## **ADDENDUM 03**

### **DELAWARE TECHNICAL & COMMUNITY COLLEGE ALLIED HEALTH – C-WING ADDITION & RENOVATIONS**

**Project Name:** Delaware Technical & Community  
College – Allied Health, “C” Wing  
Addition & Renovation

**Subject:** **ADDENDUM 3**

| Reference: | M121 | Sheet: | MSK-007 |

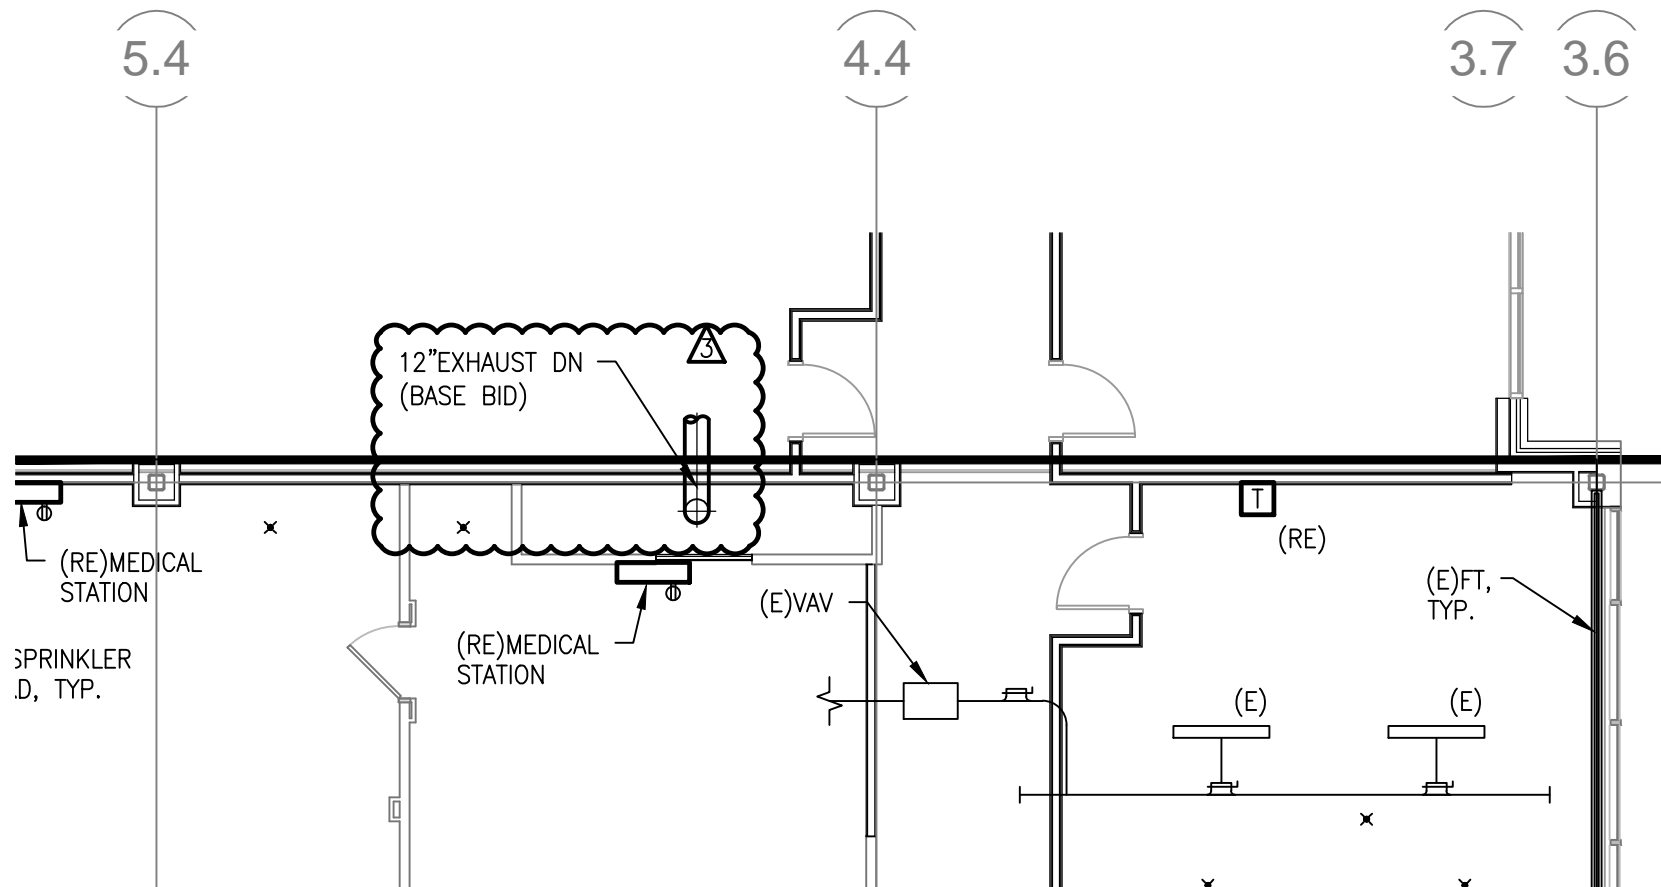
| <b>D-9</b>  |  | <p><b>Drawing M121 – 1<sup>st</sup> Floor Plan - Piping:</b></p> <p>a.) Shorten FTR in Lab Coord. C142 to stop at chase wall. Refer to Engineer’s Supplemental Sketch <b>MSK-007</b>.</p>  |

| Reference: | M114 | Sheet: | MSK-008 |

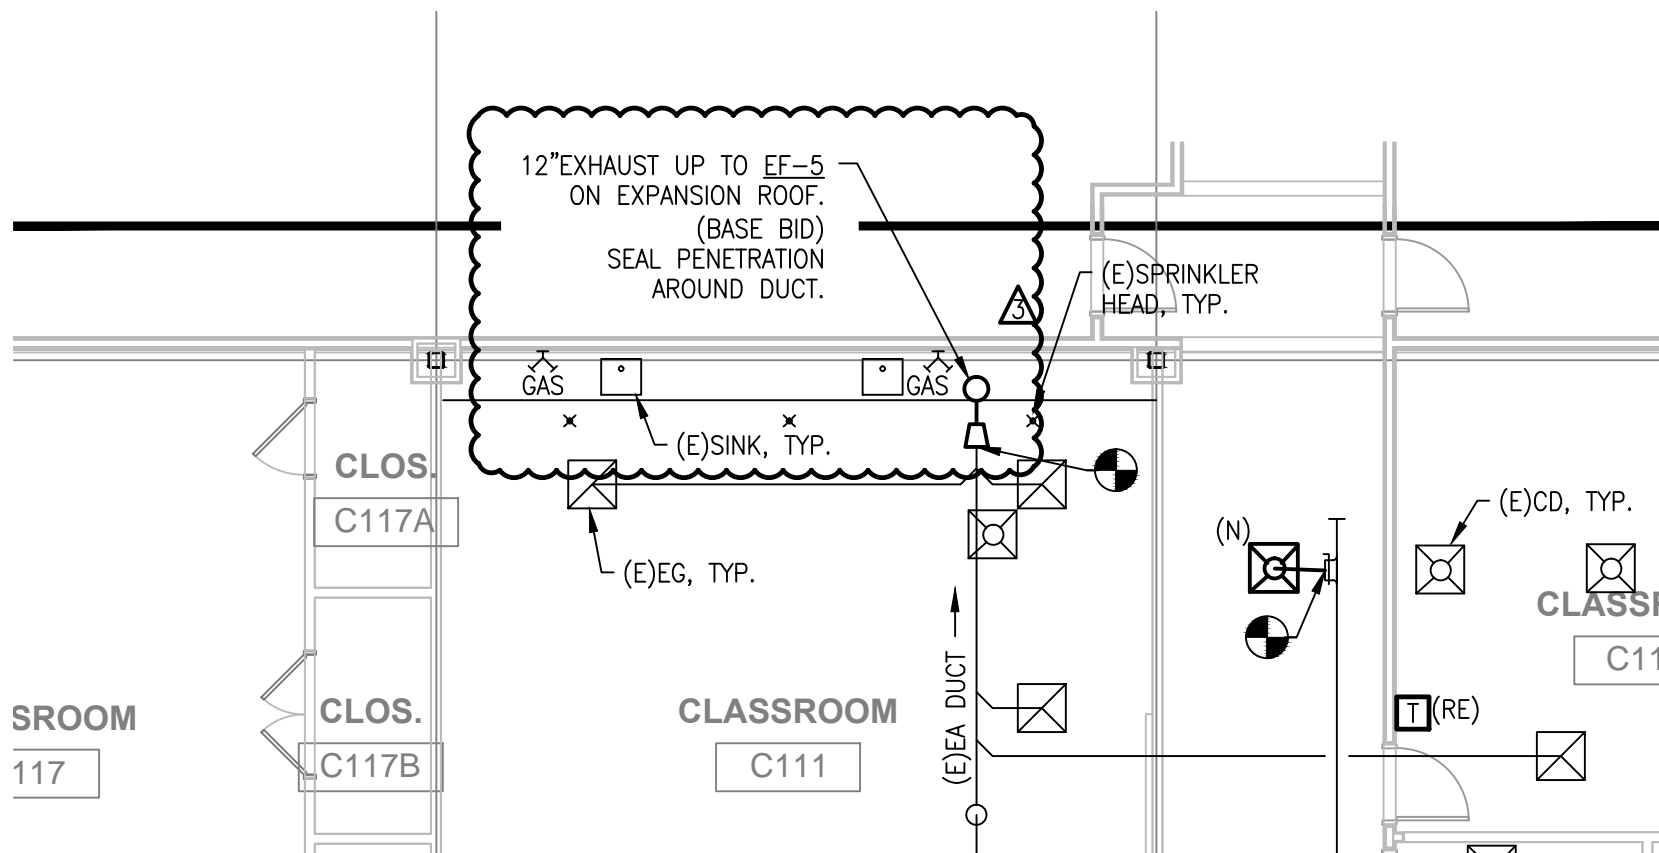
| <b>D-10</b> |  | <p><b>Drawing M114 – 2<sup>nd</sup> Floor Plan – Ductwork:</b></p> <p>a.) 18” Exhaust ductwork within chase modified to 12” round ductwork. Refer to Engineer’s Supplemental Sketch <b>MSK-008</b>.</p>                              |

| Reference: | P111 | Sheet: | PSK-001 |

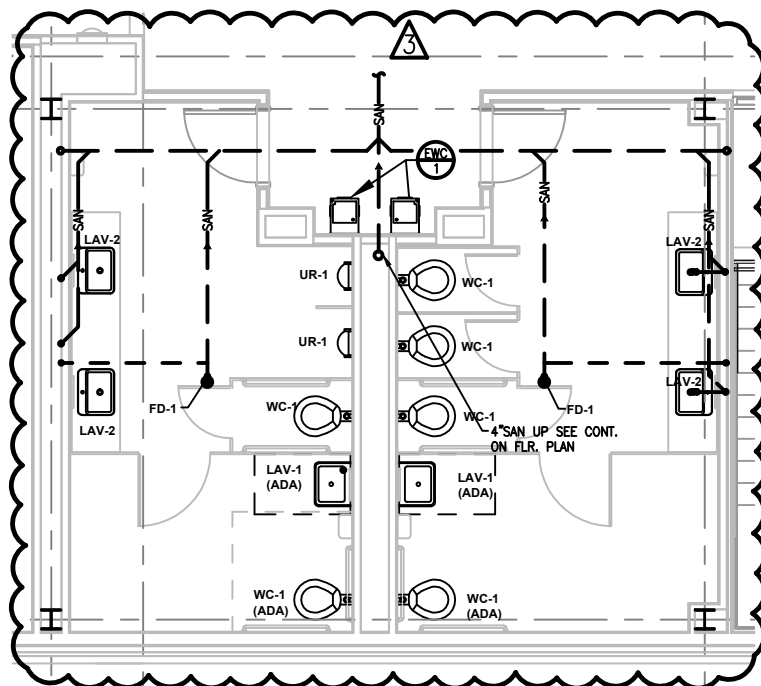
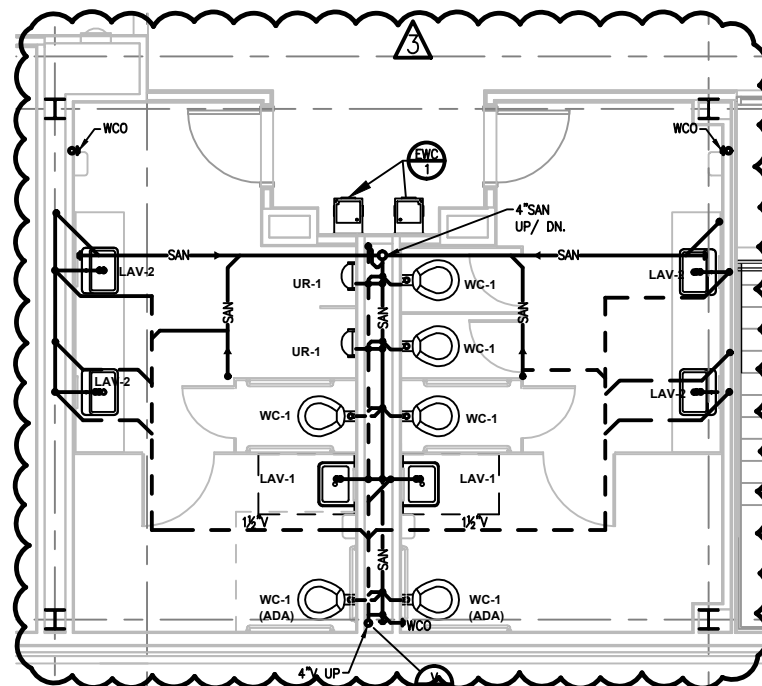
| <b>D-12</b> |  | <p><b>Drawing P111 – 1<sup>st</sup> Floor Plan – Base Bid:</b></p> <p>a.) Bathroom backgrounds updated to match architectural. Fixture types modified. Refer to Engineer’s Supplemental Sketch <b>PSK-001</b>.</p>                   |

Reference: **P601** Sheet: **PSK-002**

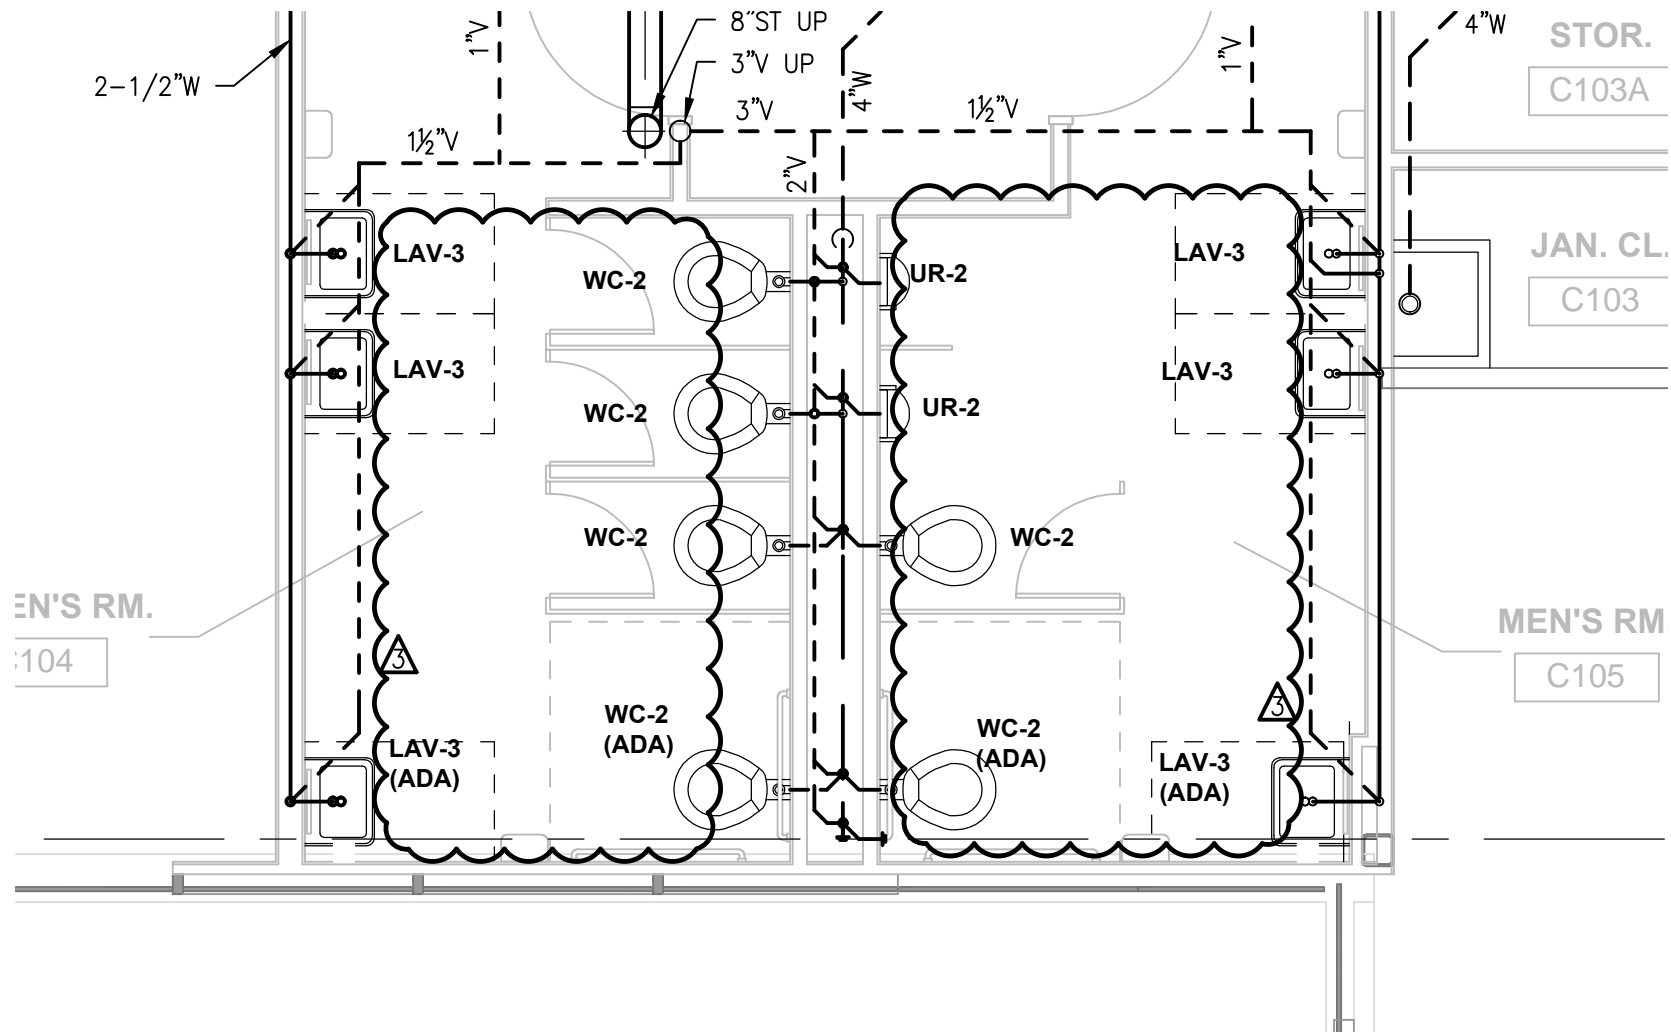
| <b>D-13</b> |  | <p><b>Drawing P601 – Plumbing Fixture Schedule:</b></p> <p>a.) Plumbing Fixtures modified. Refer to Engineer’s Supplemental Sketch <b>PSK-002</b>.</p>   |

| Reference: | P438 | Sheet: | PSK-003 |

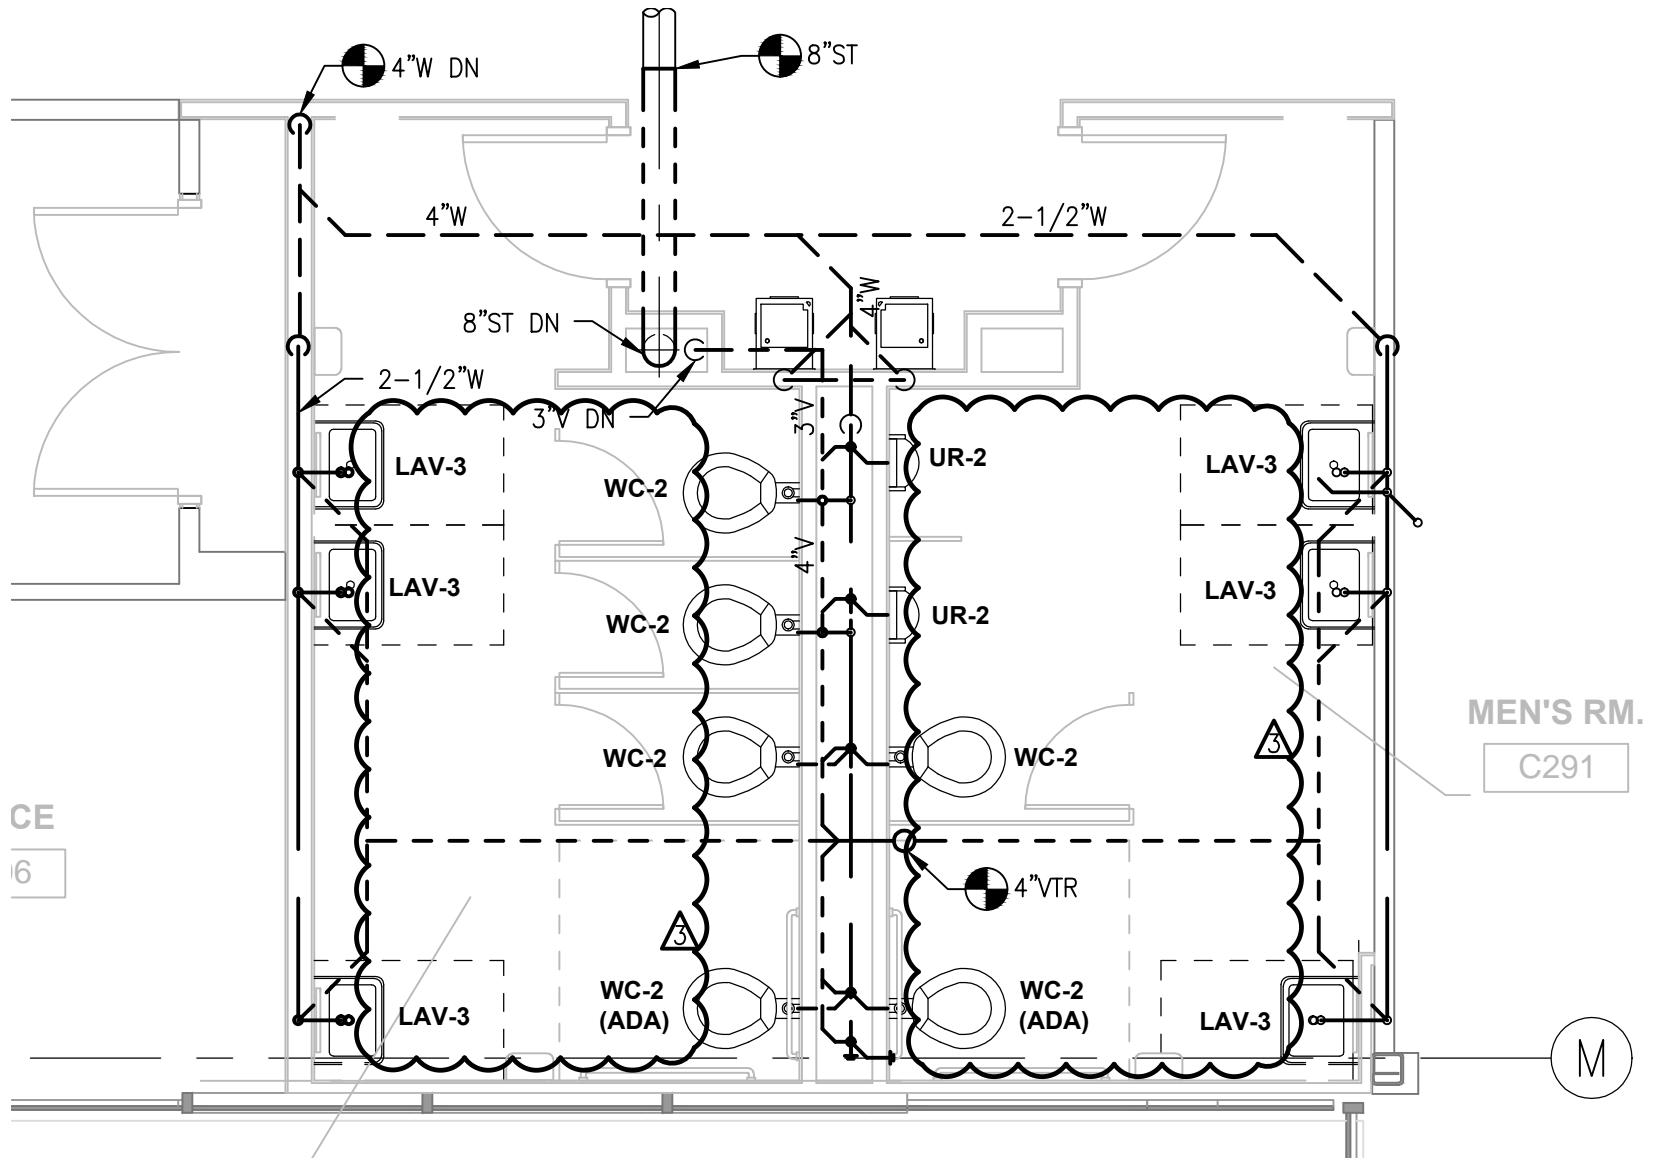
|             |  | <p>a.) Plumbing fixture types modified. Refer to Engineer’s Supplemental Sketch <b>PSK-003</b>.</p> <p>b.) Plumbing fixture types modified. Refer to Engineer’s Supplemental Sketch <b>PSK-004</b>.</p>  |

| Reference: | P439 | Sheet: | PSK-005 |

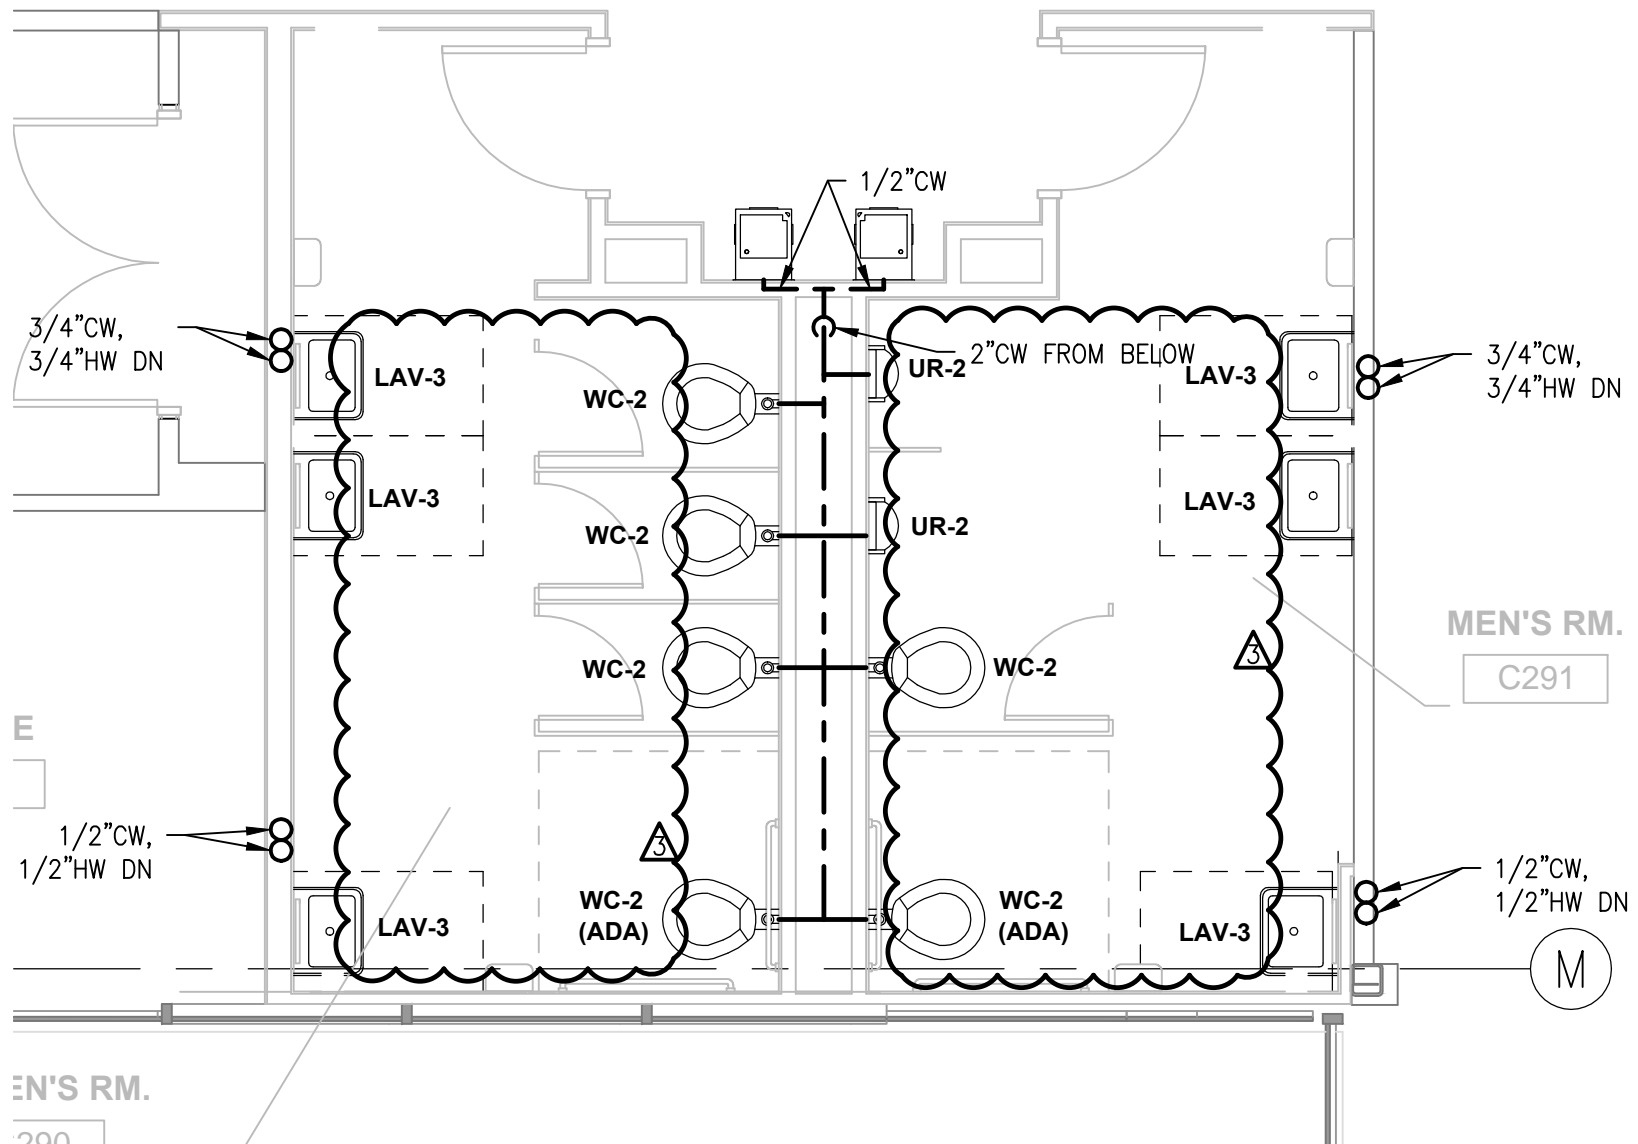
| <b>D-16</b> |  | <p><b>Drawing P439 – 1<sup>st</sup> Floor New Work – Domestic Water – Alt. 4:</b></p> <p>a.) Plumbing fixture types modified. Refer to Engineer’s Supplemental Sketch <b>PSK-005</b>.</p> <p>b.) Plumbing fixture types modified. Refer to Engineer’s Supplemental Sketch <b>PSK-006</b>.</p>  |

| Reference: | P113 | Sheet: | PSK-007 |

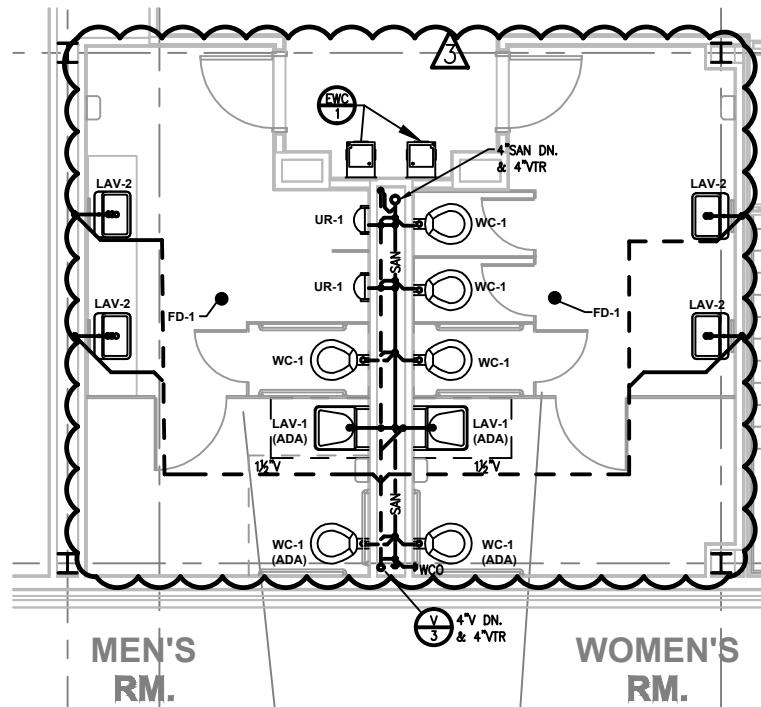
| <b>D-?</b>  |  | <p><b>Drawing P113 – 2<sup>nd</sup> Floor New Work – Sanitary:</b></p> <p>a.) Bathroom backgrounds updated to match architectural. Fixture types modified. Refer to Engineer’s Supplemental Sketch <b>PSK-007</b>.</p>               |

| Reference: | P121 | Sheet: | PSK-008 |

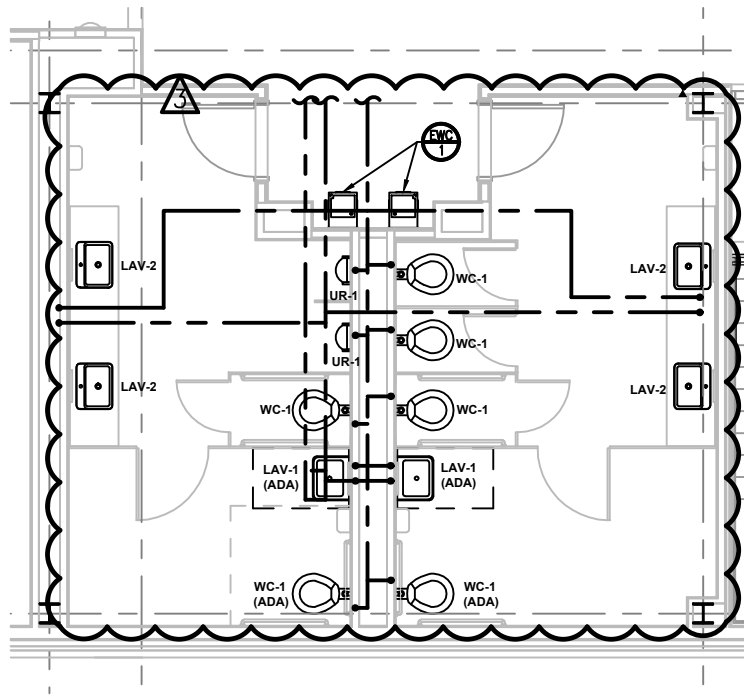
| <b>D-?</b>  |  | <p><b>Drawing P121 – 1<sup>st</sup> Floor New Work – Domestic Water:</b></p> <p>a.) Bathroom backgrounds updated to match architectural. Fixture types modified. Refer to Engineer’s Supplemental Sketch <b>PSK-008</b>.</p>         |

| Reference: | P123 | Sheet: | PSK-009 |

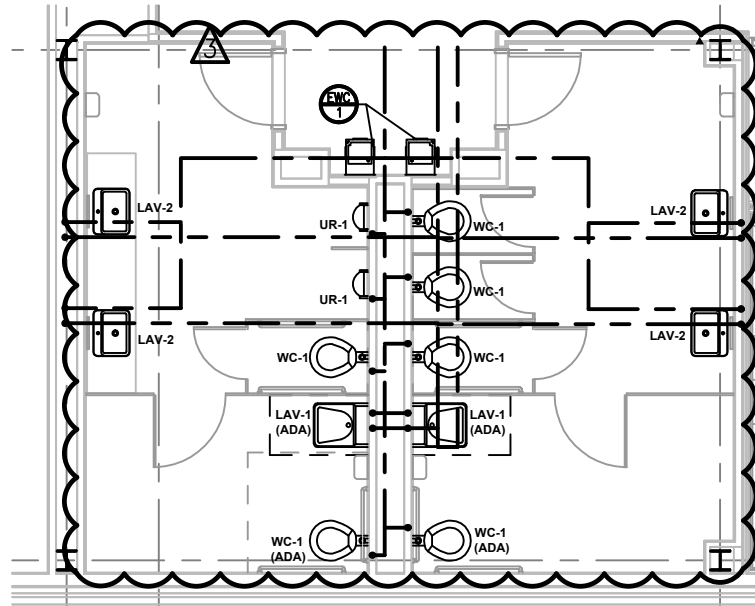
| <b>D-?</b>  |  | <p><b>Drawing P123 – 2<sup>nd</sup> Floor New Work – Domestic Water:</b></p> <p>a.) Bathroom backgrounds updated to match architectural. Fixture types modified. Refer to Engineer’s Supplemental Sketch <b>PSK-009</b>.</p>         |
